WCAP-14483-A

Generic Methodology for Expanded Core Operating Limits Report

SUBJECT: ACCEPTANCE FOR REFERENCING OF LICENSING TOPICAL REPORT
WCAP-14483, "GENERIC METHODOLOGY FOR EXPANDED CORE
OPERATING LIMITS REPORT" (TAC NO. M94338)

SAFETY EVALUATION BY THE OFFICE OF NUCLEAR REACTOR REGULATION
RELATING TO TOPICAL REPORT WCAP-14483
GENERIC METHODOLOGY FOR EXPANDED CORE OPERATING LIMITS REPORT

Figure 2.1.1-1 (page 1 of 1)
Reactor Core Safety Limits

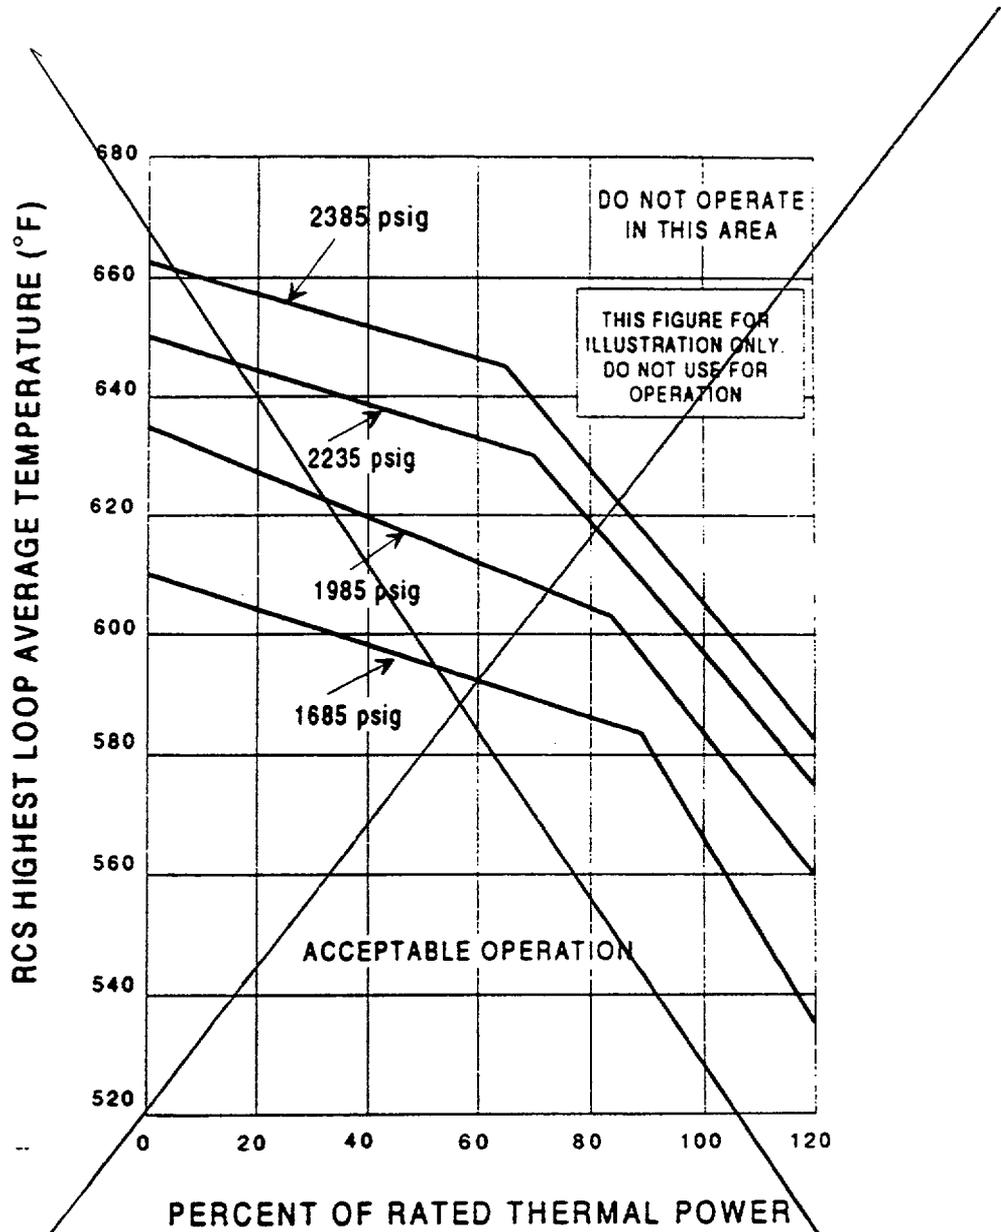
The current TS figure (2.1.1-1) presents core limits on RCS temperature conditions (T-avg) as a function of pressurizer pressure and fractional rated thermal power. This figure was originally included in the Westinghouse TS to satisfy the requirements of 10CFR50.36 which states that "safety limits for nuclear reactors are limits upon important process variables that are found to be necessary to reasonably protect the integrity of certain physical barriers that guard against the uncontrolled release of radioactivity." However, the figure is not a complete representation of reactor core safety limits but is intended to provide the relationship between the process variables that are available to the operator (i.e., T-avg, pressurizer pressure, and thermal power) and the DNB design basis safety limit.

To ensure that the requirements of 10CFR50.36 are met, i.e., limits upon important process variables, the WOG has proposed to retain the requirement for a Reactor Core Limits figure in the Safety Limits TS, but relocate the actual figure to the COLR and replace it with the DNB design basis limit and the fuel centerline melt limit (Ref. 2). Both of these limits are criteria that must be satisfied for normal operation and for AOOs to prevent overheating of the fuel cladding and possible cladding perforation which would result in the release of fission products to the RCS and are, therefore, the true safety limits. The reactor protection system (RPS) and the Reactor Core Limits figure would then be used to determine whether the actual DNB and fuel centerline melt safety limits were violated should an event occur that could potentially challenge them. Appropriate functioning of the RPS and the steam generator safety valves ensures that for variations in the thermal power, RCS pressure, RCS average temperature, RCS flow rate, and ΔI (percent power in top half of core minus percent power in bottom half of core), the reactor core safety limits will be satisfied during steady-state operation, normal operational transients, and AOOs. Therefore, in the event of an AOO, verification that the RPS and the main steam system safety valves are functioning as designed will ensure that all safety limits are met. In the event that the RPS is not functioning as designed, an evaluation of any

It is recognized that DNB and fuel centerline melt are the true safety limits. However, since these are not measurable quantities, they do not meet the requirements of 10CFR 50.36 which states that technical specification safety limits are limits upon important process variables. Justify how the requirements of 10 CFR 50.36 would still be met if Figure 2.1.1-1 were deleted.

- 1) It is recognized that DNB and fuel centerline melt are the true safety limits. However, since these are not measurable quantities, they do not meet the requirements of 10 CFR 50.36 which states that technical specification safety limits are limits upon important process variables. Justify how the requirements of 10 CFR 50.36 would still be met if Figure 2.1.1-1 were deleted.

The staff concludes that the Reactor Core Limits figure may be relocated to the COLR and replaced with the DNB design basis limit and the fuel centerline melt limit. The NRC-approved methodology used to derive the parameters in the figure is contained in WCAP-9272-P-A, "Westinghouse Reload Safety Evaluation Methodology," dated July 1985, (or other applicable approved reload methodology), and will be referenced in the Reporting Requirements section of the TS.

Technical Specification Figure 2.1.1-1 provides a relationship between the process variables of T_{avg} , pressurizer pressure, and rated thermal power, and the DNB design basis limit. This Figure is a representation of "reactor core limits" and is not a complete representation of reactor core safety limits. The Figure can change on a cycle specific basis due to changes to $F_{\Delta H}$ and RCS flow rate. As discussed in WCAP-14483, and stated above, the reactor core safety limits are DNB design basis limit and fuel centerline melt. The Reactor Protection System and the reactor core limits (Figure 2.1.1-1) would be used to determine whether the actual reactor core safety limits (DNB design basis limit and fuel centerline melt) were violated, should an event occur that could potentially challenge them. The Applicable Safety Analyses Section of the Bases of Technical Specification 2.1.1, contained in WCAP-14483, discusses verification of reactor core Safety Limits. This Figure is not used by the operators during plant operation. The relevant DNB process variables used by the operators are addressed by the Technical Specification requirements for RCS pressure, temperature, and flow.

To ensure that the requirements of 10CFR50.36 are met, i.e., limits upon important process variables, it is proposed that the requirement for a Reactor Core Limits Figure (2.1.1-1) be retained in the Technical Specifications, but contained in the Core Operating Limits Report (COLR), consistent with Generic Letter 88-16. The methodology used to calculate the reactor core limits figure is contained in WCAP-9272-P-A, "Westinghouse Reload Safety Evaluation Methodology", July 1985.

Figure B 2.1.1-1 (page 1 of 1)
Reactor Core Safety Limits vs. Boundary of Protection

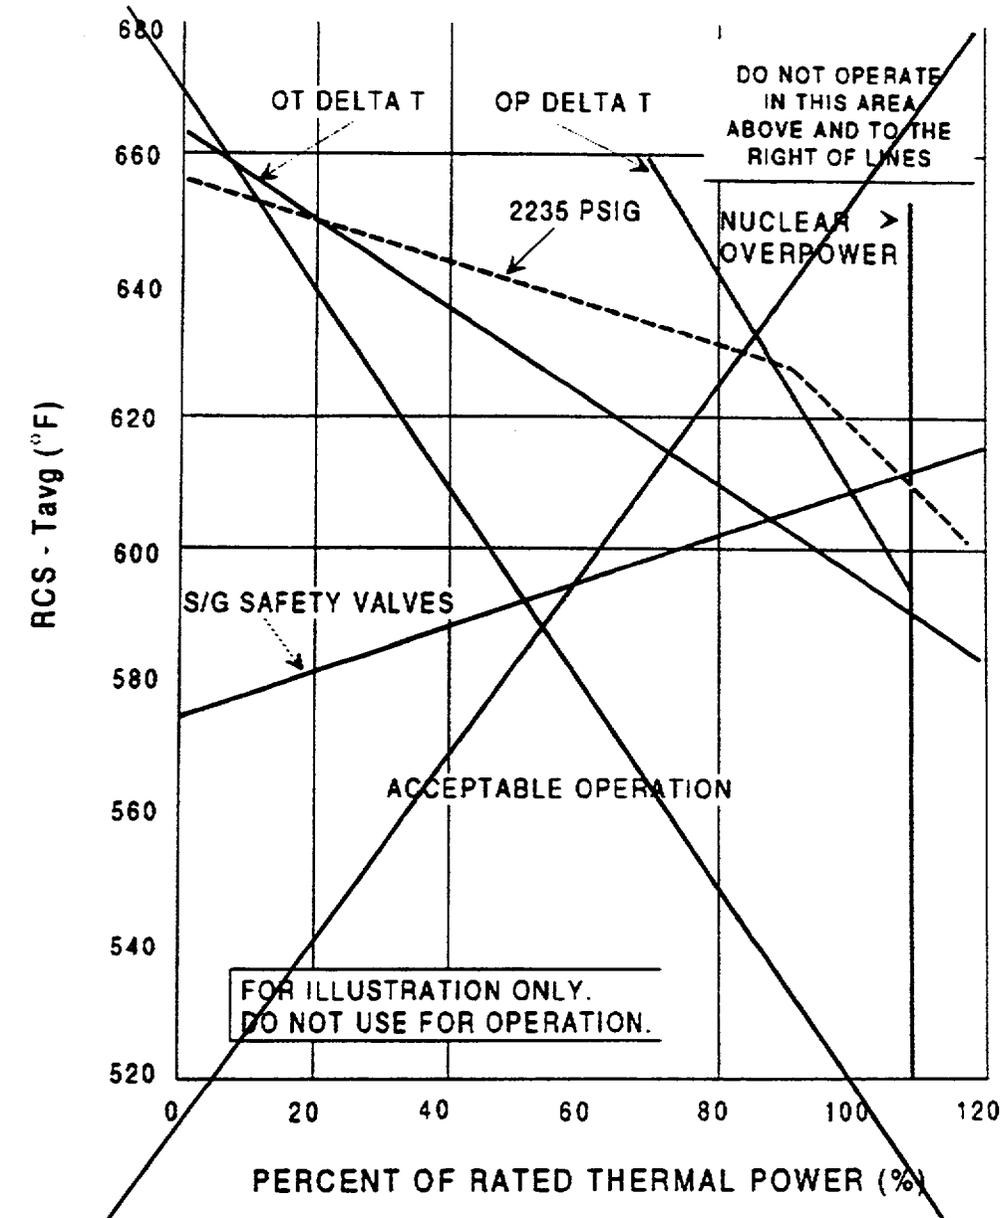
~~The curves provided in Figure B 2.1.1-1 show the loci of points of THERMAL POWER, RCS pressure, and average temperature for which the minimum DNBR is not less than the safety analyses limit, that fuel centerline temperature remains below melting, that the average enthalpy in the hot leg is less than or equal to the enthalpy of saturated liquid, or that the exit quality is within the limits defined by the DNBR correlation.~~

~~The curves are based on enthalpy hot channel factor limits provided in the COLR. The dashed line of Figure B 2.1.1-1 shows an example of a limit curve at 2235 psig. In addition, it illustrates the various RPS functions that are designed to prevent the unit from reaching the limit.~~

~~The SL is higher than the limit calculated when the AFD is within the limits of the $F_1(\Delta T)$ function of the overtemperature ΔT reactor trip. When the AFD is not within the tolerance, the AFD effect on the overtemperature ΔT reactor trips will reduce the setpoints to provide protection consistent with the reactor core SLs (Refs. 3 and 4).~~
